**THE ENVIRONMENTAL LAW & POLICY CENTER,
IOWA ENVIRONMENTAL COUNCIL, AND SIERRA CLUB**

**MIDAMERICAN ENERGY COMPANY'S FINAL RESOURCE
EVALUATION STUDY REPORT**

March 3, 2025

Figure 2. Completed MISO Solar Interconnection Agreements (Updated Queue Data as of 12/30/2024)

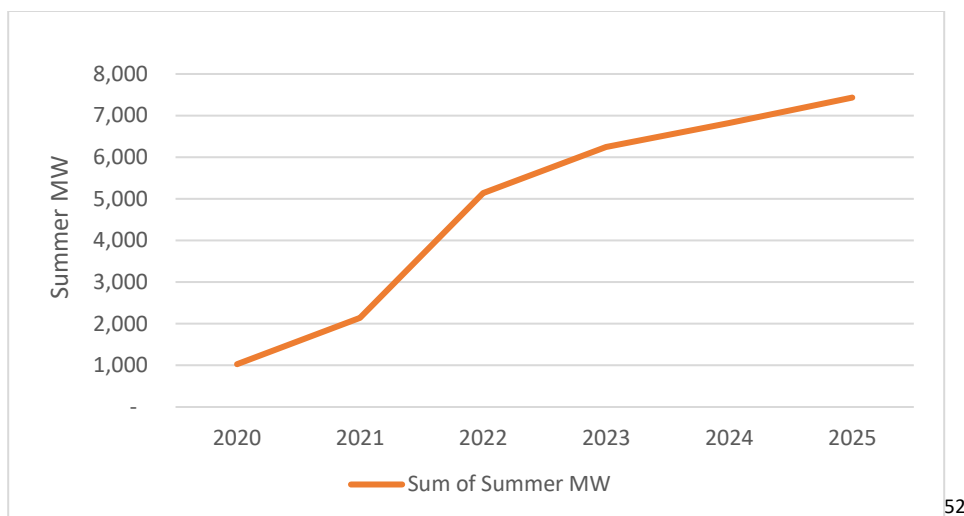
MidAmerican’s own methodology, informed by the most recent MISO interconnection data, would allocate 500 MW of solar to MidAmerican per year. And there is reason to believe that interconnection and permitting constraints will improve over the mid-to-long-term. Processes are being revised and improved in response to changes in the energy industry. With notable recent actions by MISO, PJM, and the Federal Energy Regulatory Commission (FERC) to reform the interconnection process, signs point towards more efficient and lower cost processes in the future.^{53, 54}

Figure 11. Solar built by model (2024-2044)

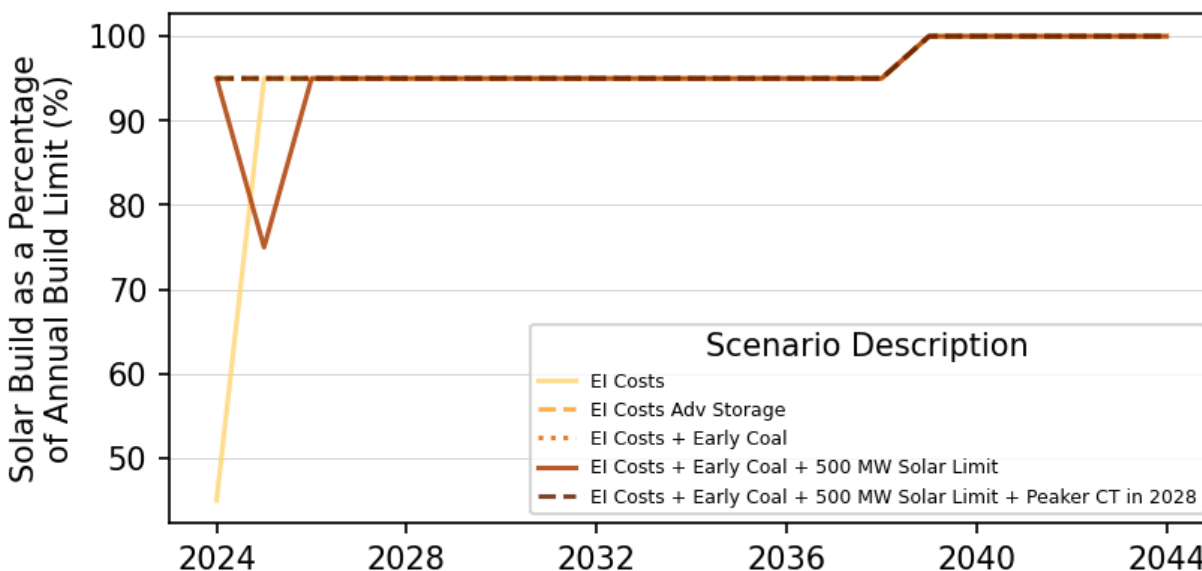
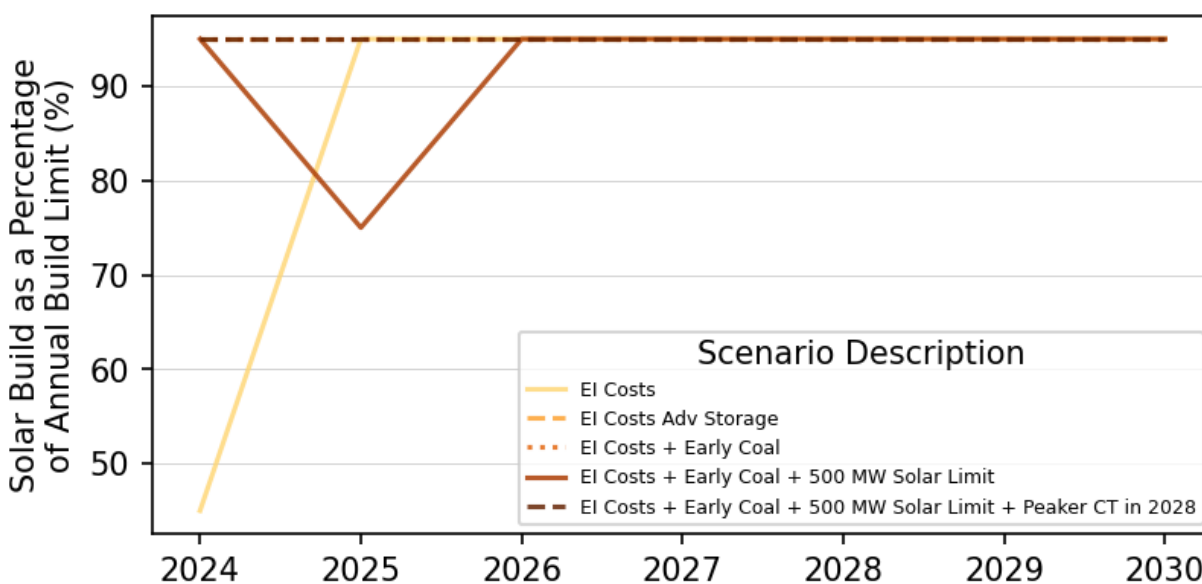
MidAmerican has also expressed skepticism that it can feasibly bring online any new solar PV before 2028.⁹¹ But the Company's RES modeling results show that solar additions before 2028 are economic across scenarios and sensitivities.

- MidAmerican should procure as much cost-effective solar as the market will provide, without limiting acquisition based on the limit MidAmerican set of 300 MW each year.
- MidAmerican should specify in a competitive market procurement that it is looking for solar resources as soon as possible, consistent with the results of the RES. MidAmerican should not limit its search to solar achieving commercial operation after 2028.
